MAINE TURNPIKE AUTHORITY

ADDENDUM NO. 2

CONTRACT
2020.03

PORTLAND AREA WIDENING &
SAFETY IMPROVEMENTS
MILE 43.0 TO MILE 46.4

STA. 2266+50 VMS
SIGN STRUCTURE AND FOUNDATION

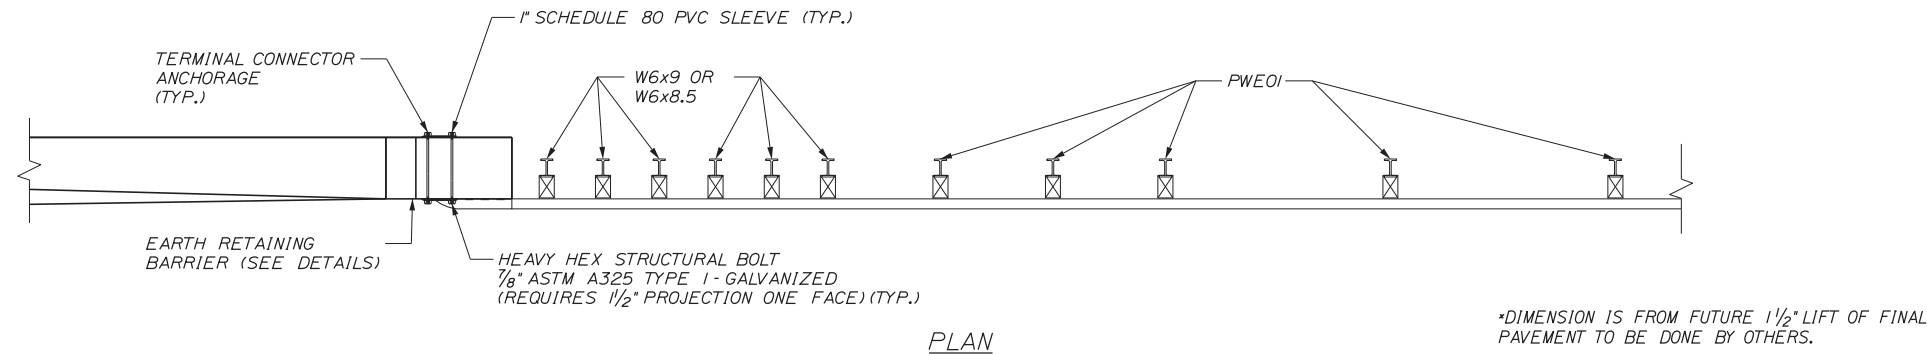
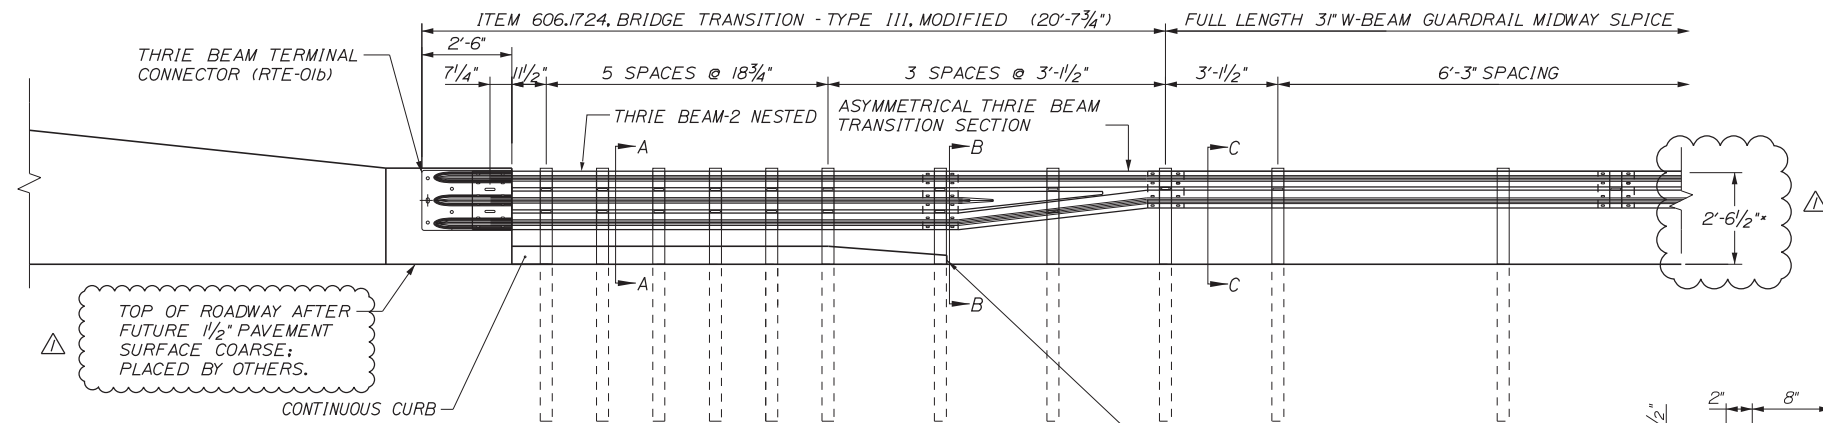
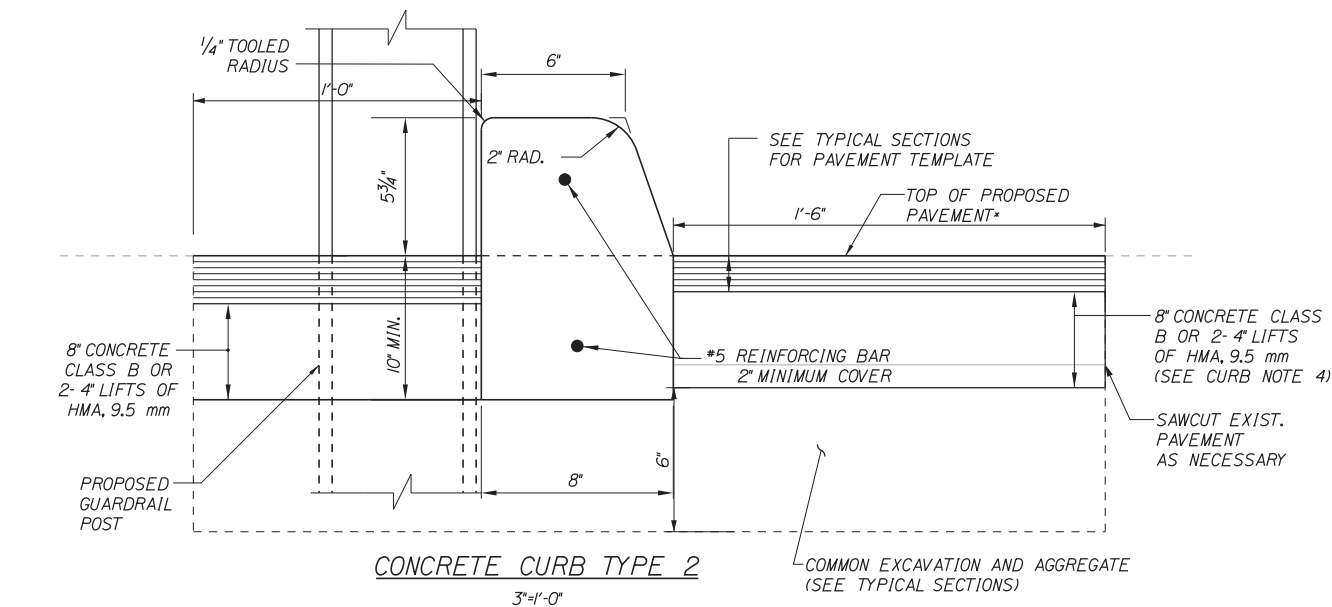
- Special Provision 650
 - The contractor shall make a “pen and ink” change to Special Provision page SP-159, first paragraph of Section 650.31 Variable Message Sign (VMS); the sentence shall be deleted and replaced with, “The VMS shall be a Daktronics model VF-2420-27x60-66-A.”

Question 9: The VMS signs specified in the contract are no longer manufactured by Daktronics. Is there a specific make and model that will be used as a substitute?
